From:William ClarkTo:Helen DonaldsonCC:David Margolis-Pineo; Jennifer ThompsonDate:6/1/2015 4:11 PMSubject:Re: Fwd: Bishop Street Draft Plat planAttachments:Bishop St No 72 Subdivision Plat Plan 5 22 2015Survey Review 6 01 2015.PDF; Bishop St No 72 Boundary and Topo SurveyRev 1 20 2015 Survey Review 5 12 2015.PDF

This is a draft subdivision plat for a 30-unit Avesta project, all apartments, out on Bishop Street. Could you take a look and let me know your comments when you have a chance?

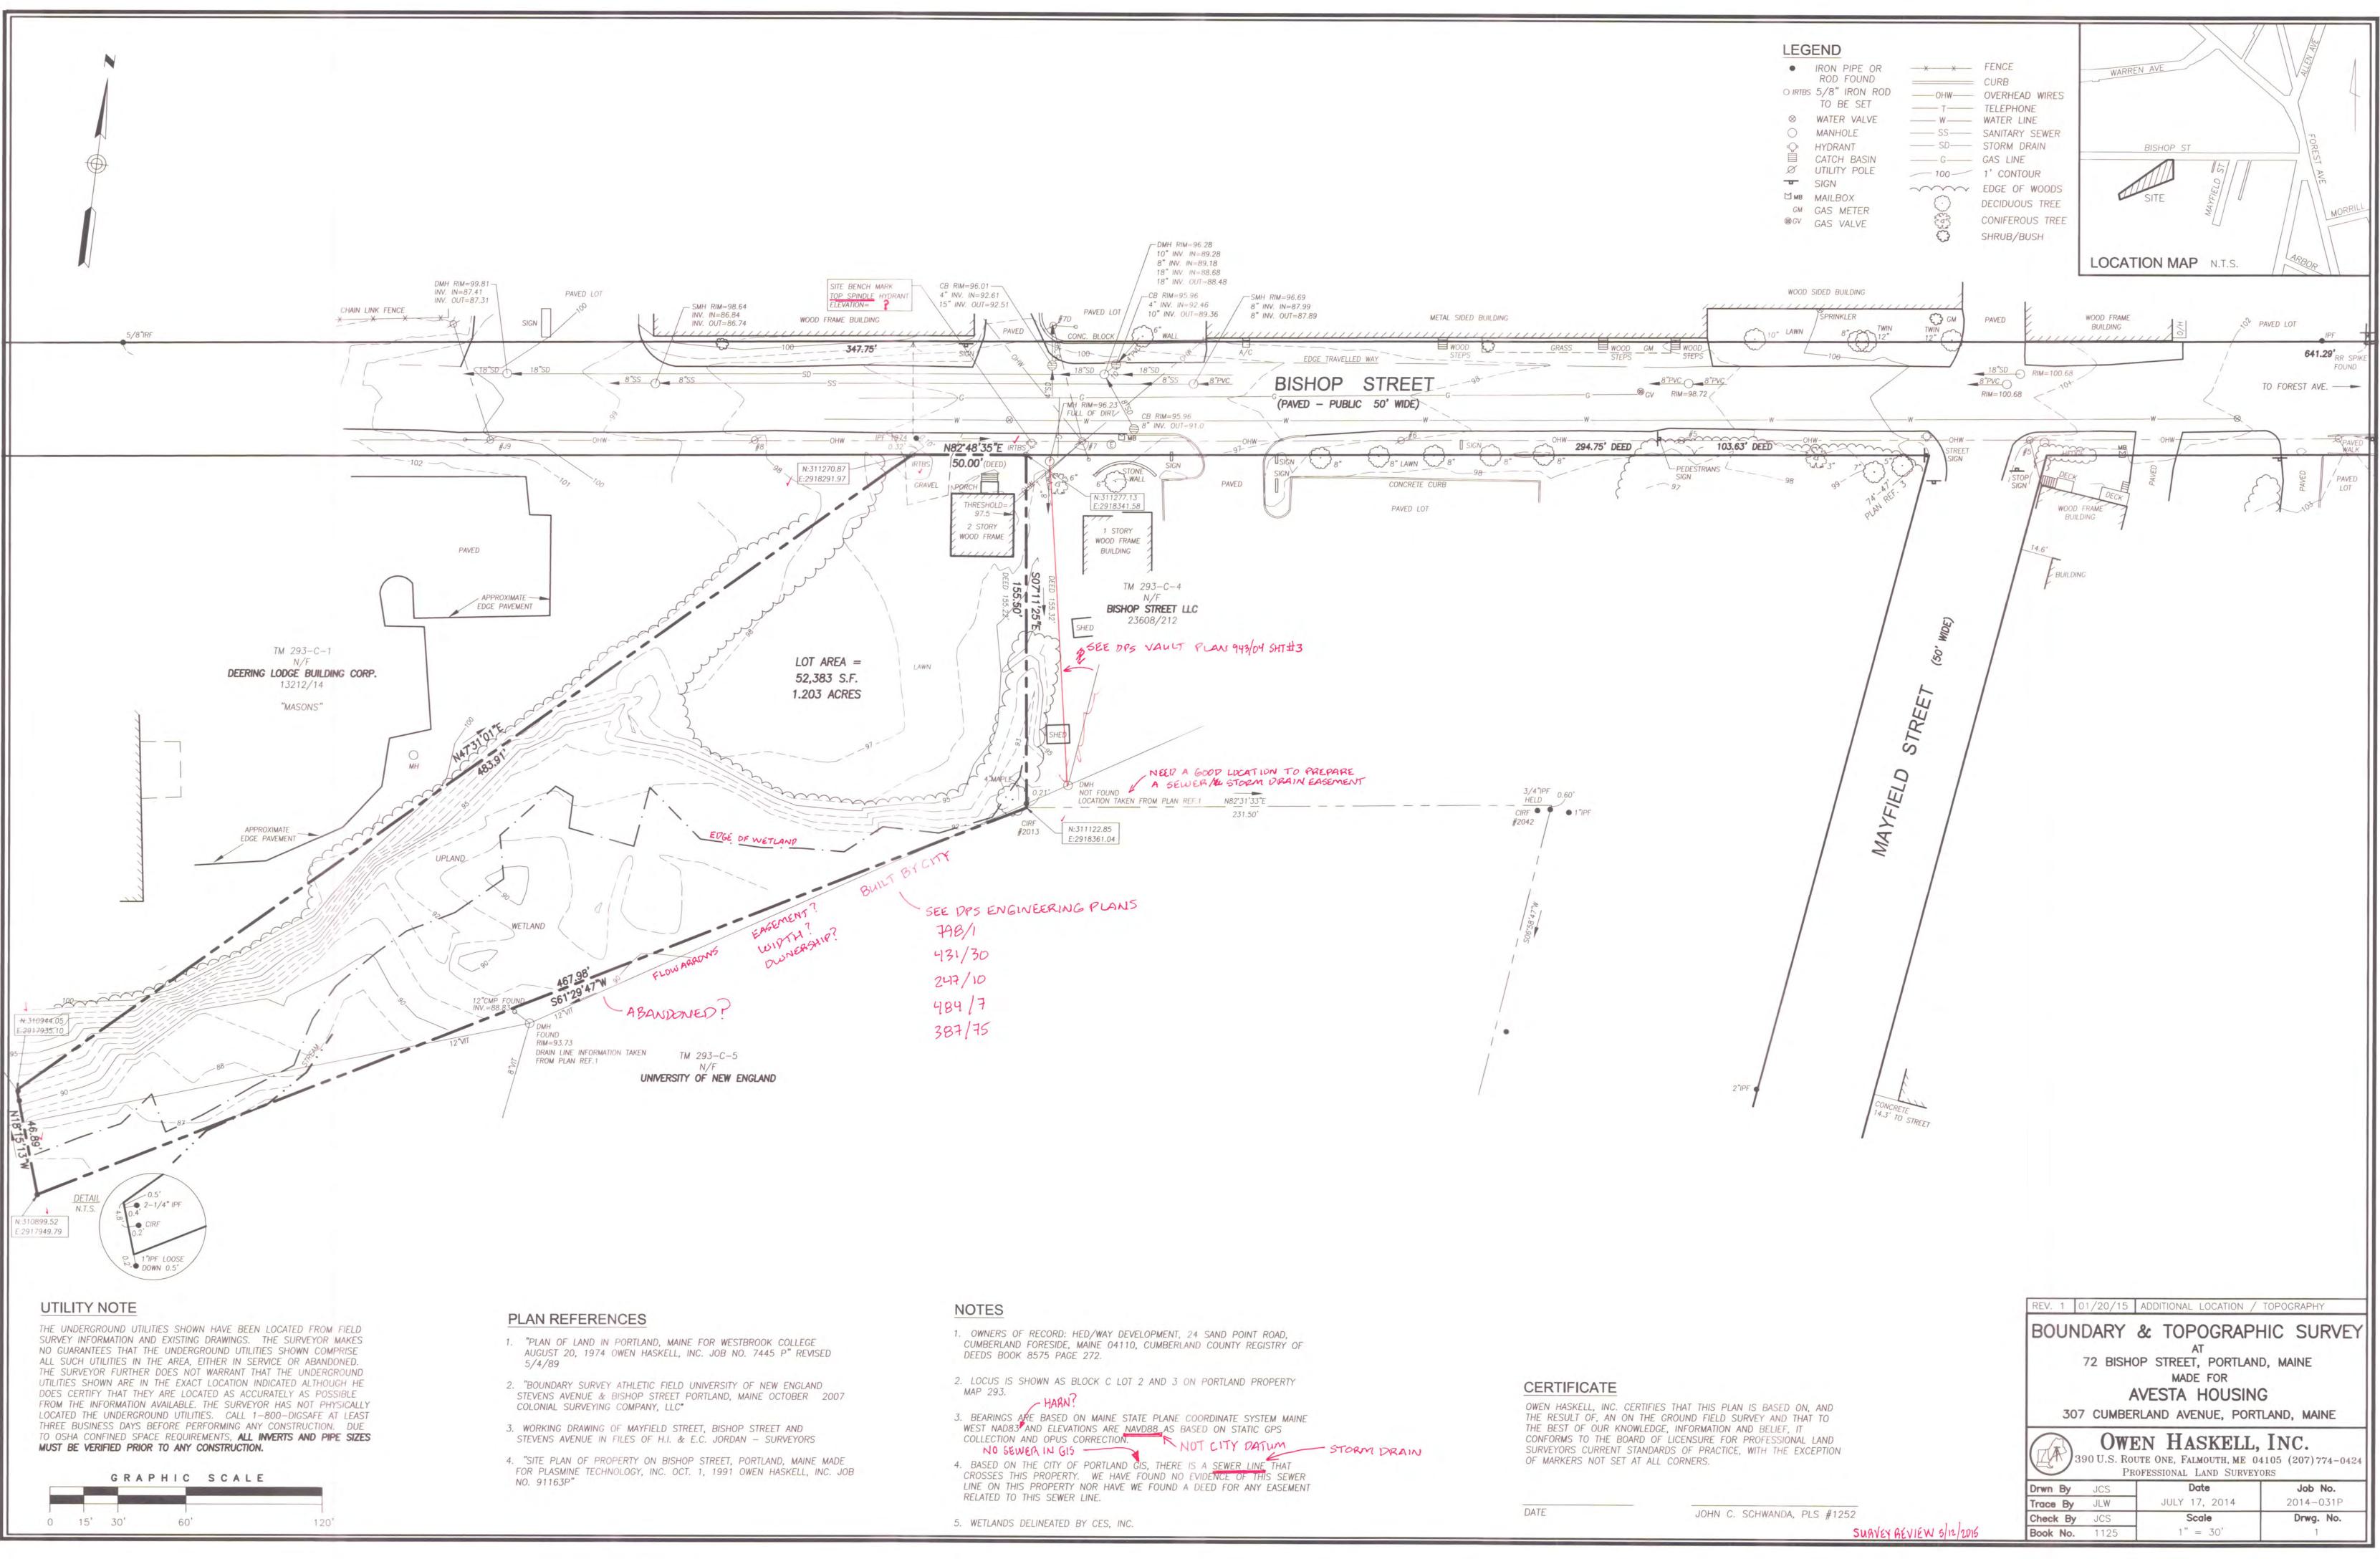
He agreed to show the proposed 30 foot storm drain easement on the plans. That has not been corrected.

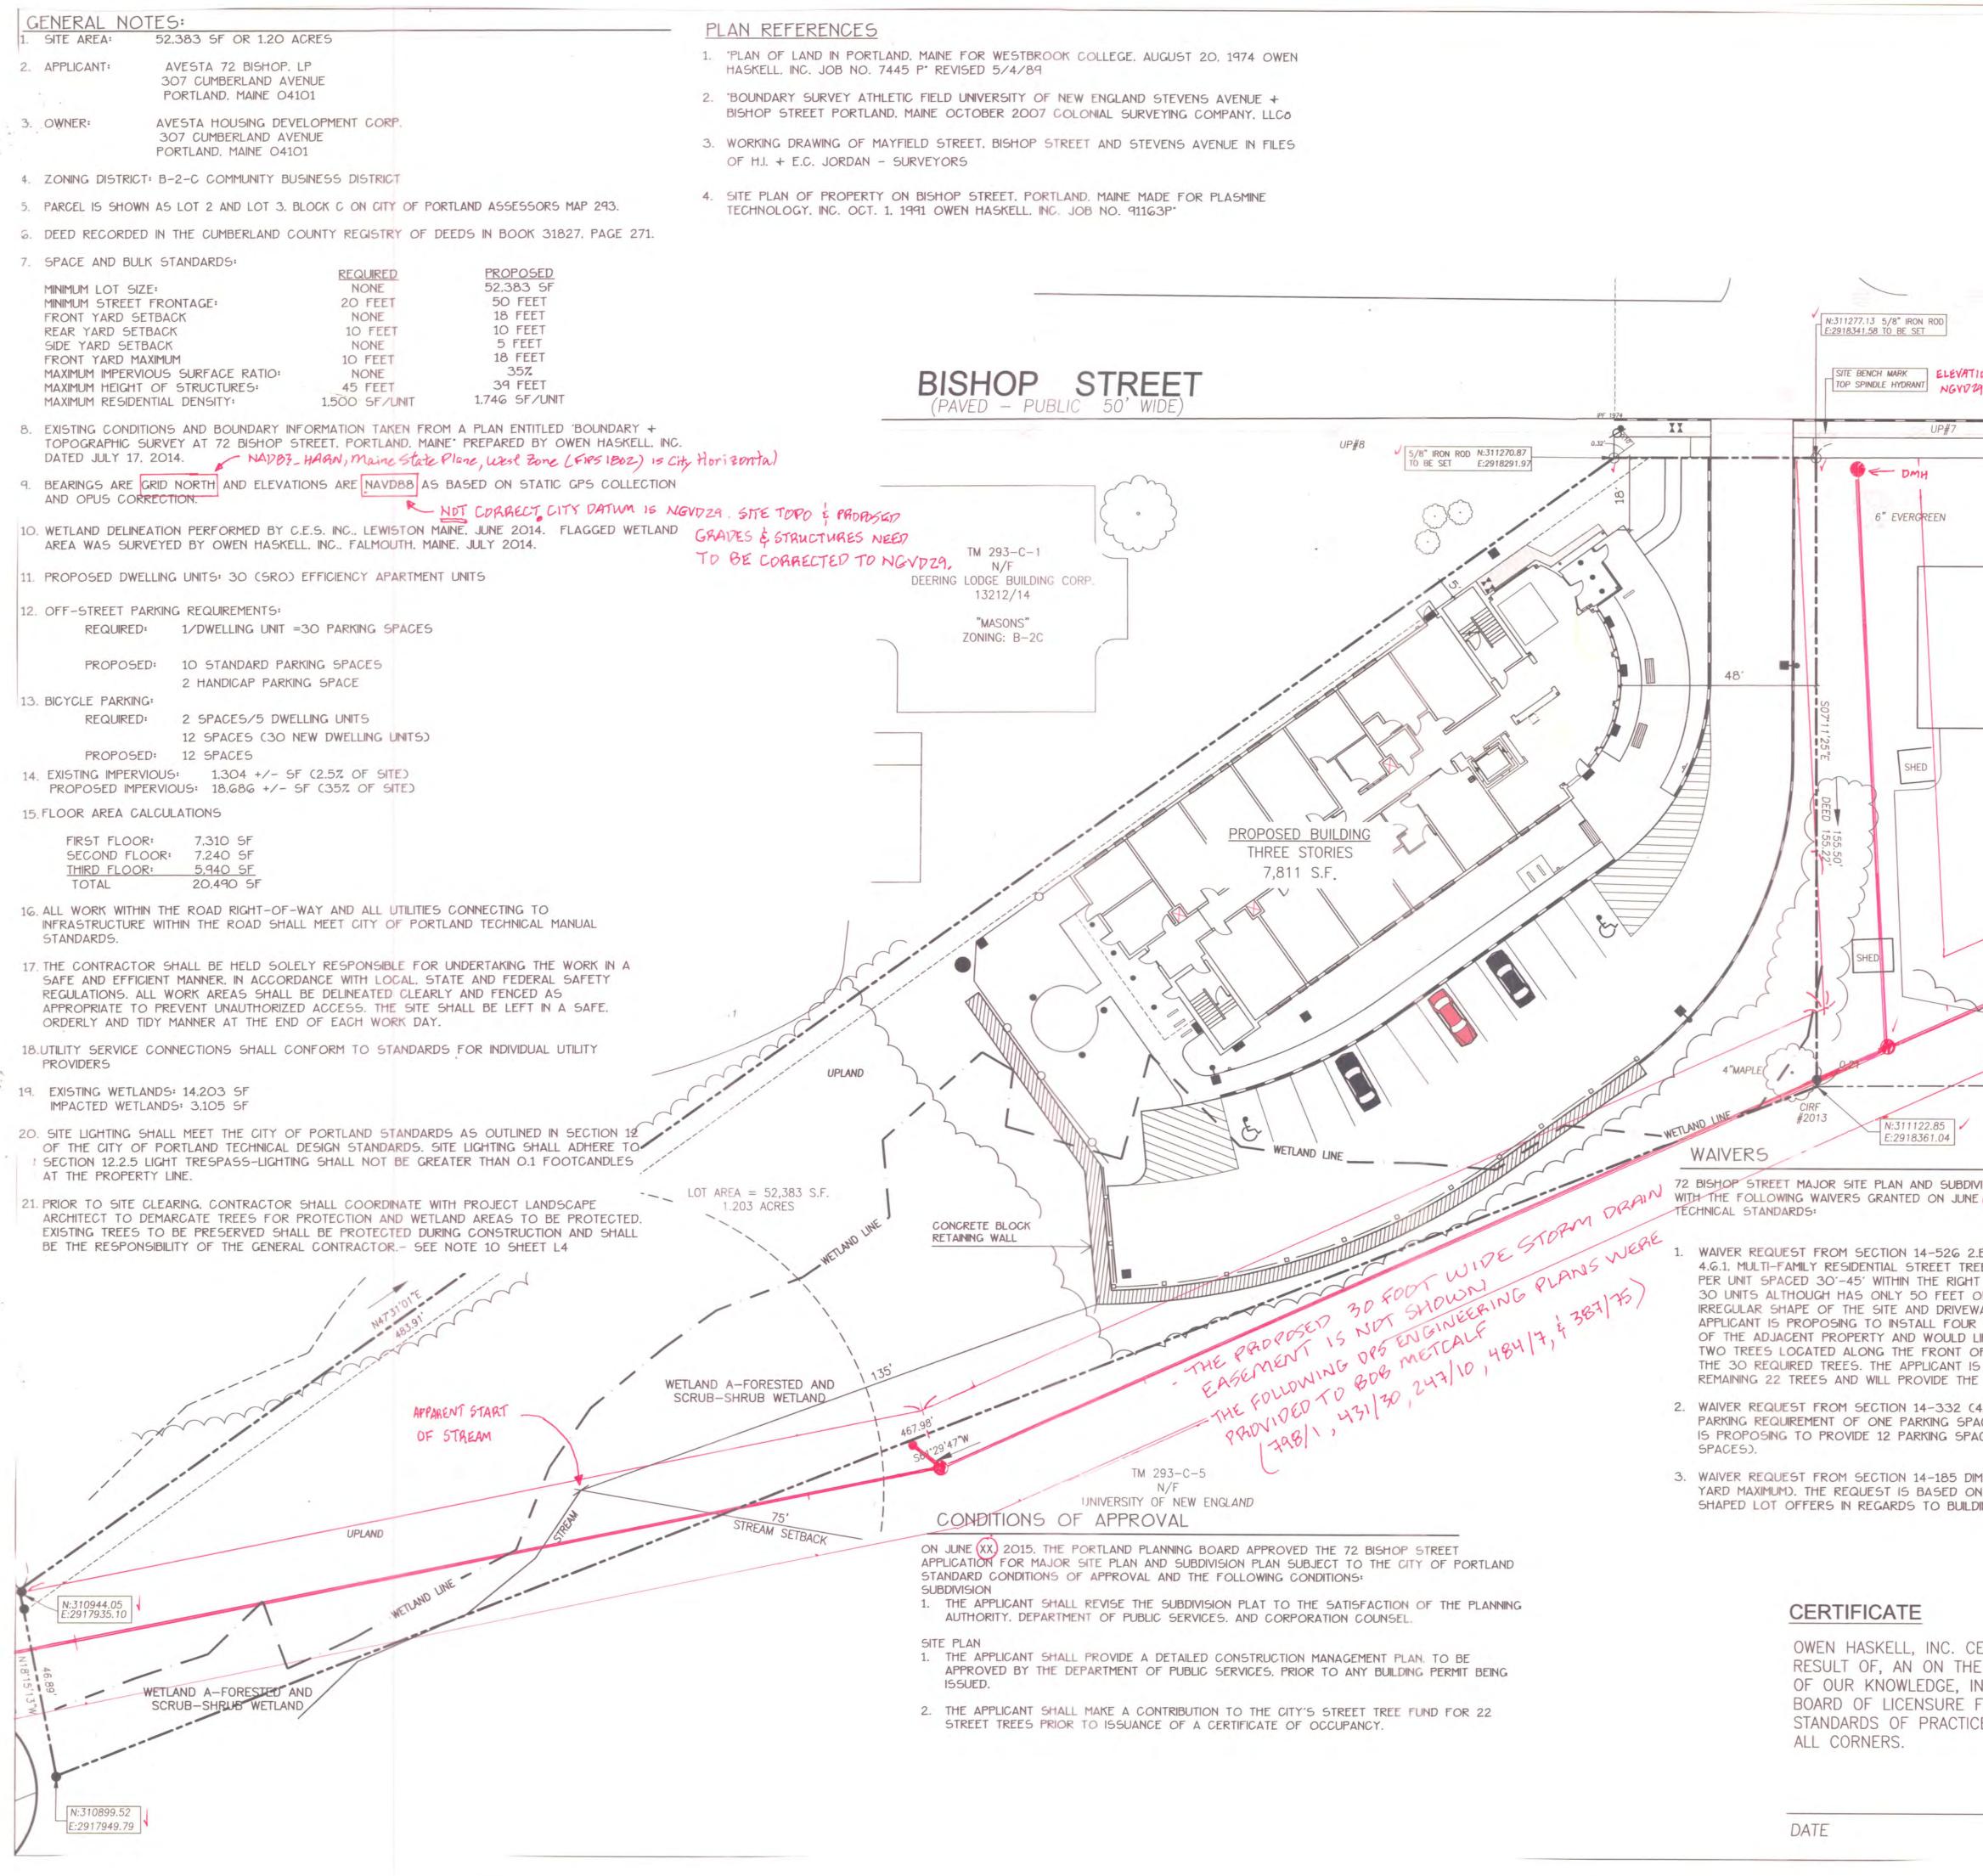
In addition, the same elevation datum problem exists on the Subdivision Plat Plan dated 5 22 2015 which you sent me this morning. They state they used NAVD88 which is not the official City datum. Existing Grades/Topo, Proposed grades, and structures need to be corrected to the Official City of Portland Datum prior to approval.
